**REPORT TO THE SUBDIVISION AND
DEVELOPMENT APPEAL BOARD**

| DATE: May 5, 2026 | APPEAL NO.: SDAB2026-0052 FILE NO.: DP2025-06986 |
| FROM A DECISION OF THE DEVELOPMENT AUTHORITY where a New: Townhouse (1 building), Secondary Suite (4 suites), Accessory Residential Building (garage) was approved at <u>4228 Voyageur Drive NW.</u> | LAND USE DESIGNATION: R-CG Discretionary |

Fire/Safety Considerations:

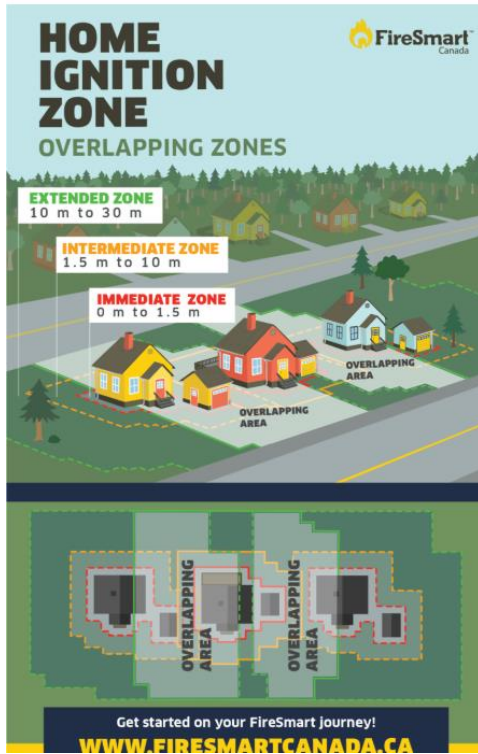
Increased development of a large vaulted structure increases risk of fire spreading towards neighbouring properties. Due to large open floor plans and vaulted ceilings ...fire it is accelerated. The overlapping ignition zone is increased. It looms over the neighbouring single family homes below and the height easily allows the fire to spread to vents or roofs of the smaller adjacent homes below. The firewall appears to stop at the underside of the ceiling line from these drawings....need more sections but it should run the full height to the roof to avoid fire jumping from one unit to the other. Fire still spreads through glass openings and attic areas.

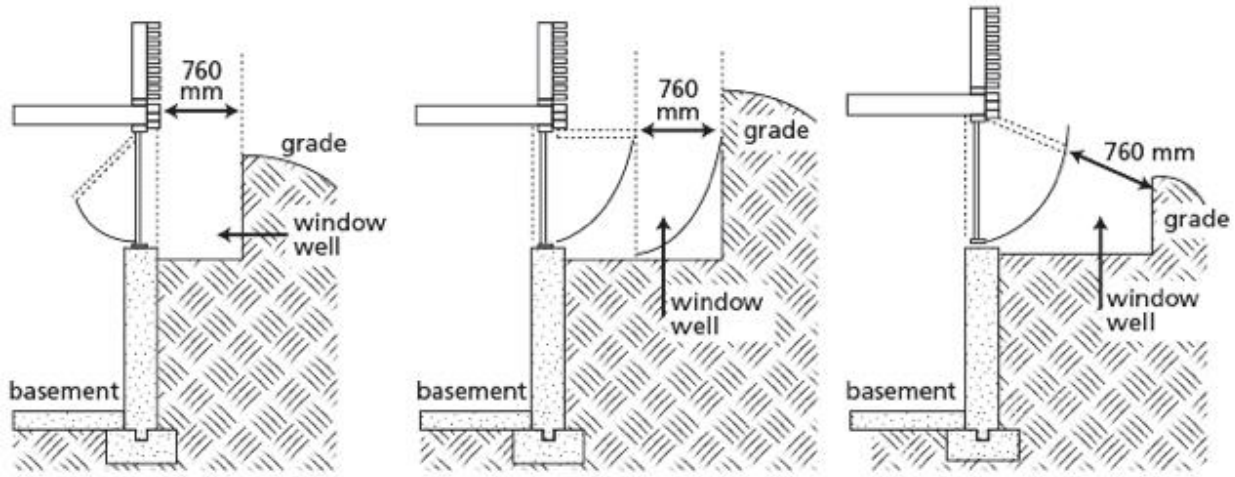
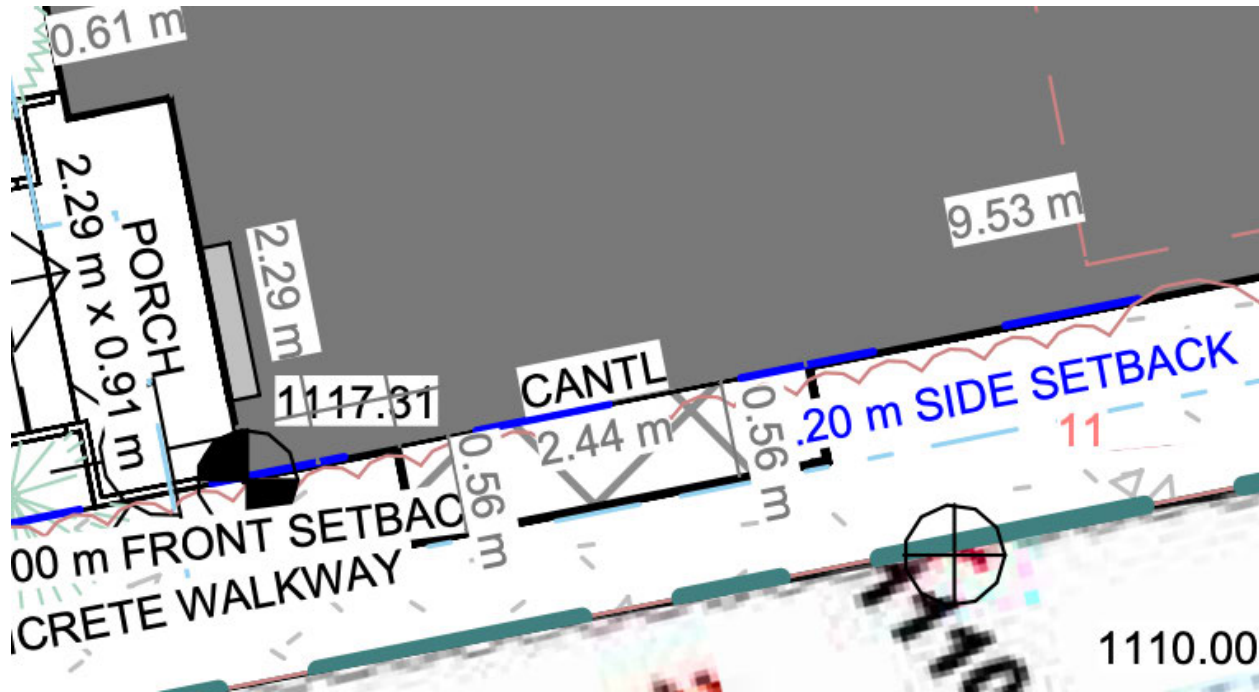
Additionally, the window wells are not acceptable by code as it should be 760 mm (30") for escape and drawings show .560 meters

The drawings indicate .560 meters with a side yard of 1.2 meters.
